Parts Information Bulletin 09
Engine Rain Cap Standoff Brackets
August 8, 2000

Locations of Standoff Brackets

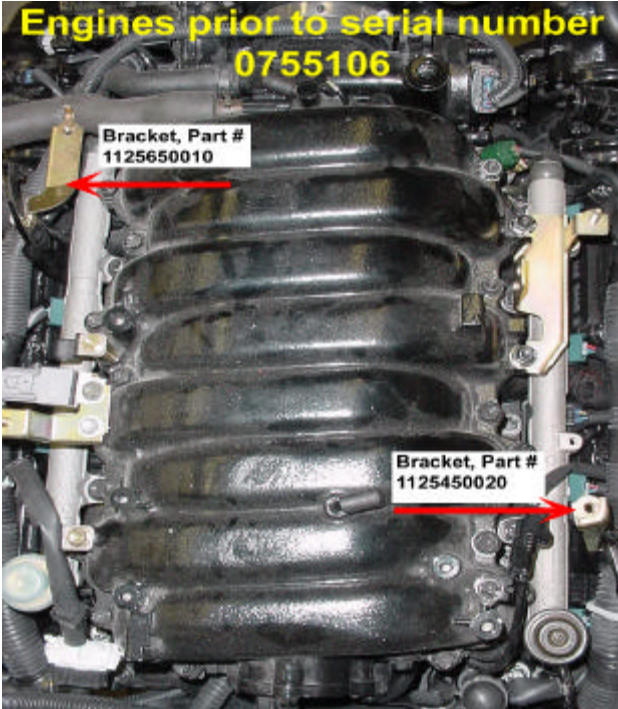
Engine Rain Cap Standoff Brackets, part numbers 1125450020 (starboard/aft), and 1125650010 (port/forward), are being replaced by newly designed brackets. The new brackets (shown above) are designed to fit on the intake manifolds of engines after serial number 0755106. Part number 1125450021 will be taking the place of part number 1125450020, and part number 1125650011 will be replacing part number 1125650010. The new brackets will not fit on the older manifolds, nor will the older brackets (shown below) fit on the manifolds of engines after serial number 0755106.

NOTE: These brackets are designed for the engines prior to serial number 0755106.

Part number 1125650010 is located on the engine at port side forward.
Part number 1125450020 is located on the engine at starboard side aft.
